Notices of requirement for designations under section 168 of the Act, in relation to Te Ahu a Turanga; Manawatū Tararua Highway Project

**STATEMENT OF EVIDENCE OF DAVID JAMES DUNLOP (TRANSPORT) ON
BEHALF OF THE NEW ZEALAND TRANSPORT AGENCY**

8 March 2019

Figure 1: Indicative vertical profile of Pahiatua Track

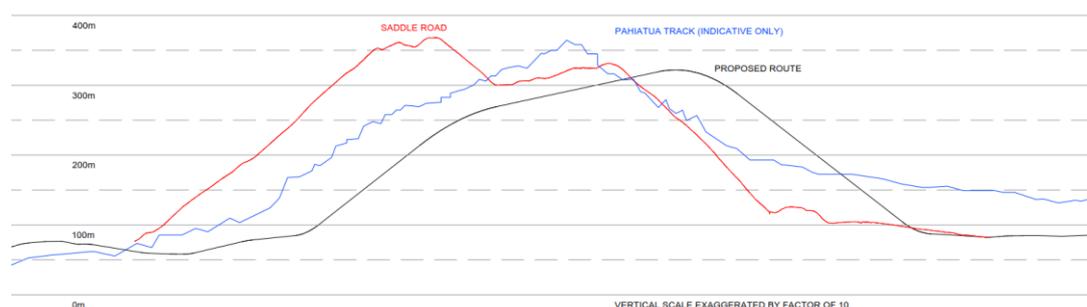
Please add, even if indicatively, the vertical alignment of Pahiatua track to the figure.

123. I have shown the vertical alignment of the Project route, Saddle Road, and Pahiatua Track in Figure 1 below. The indicative profile has been traced from a route elevation produced in Google Earth.
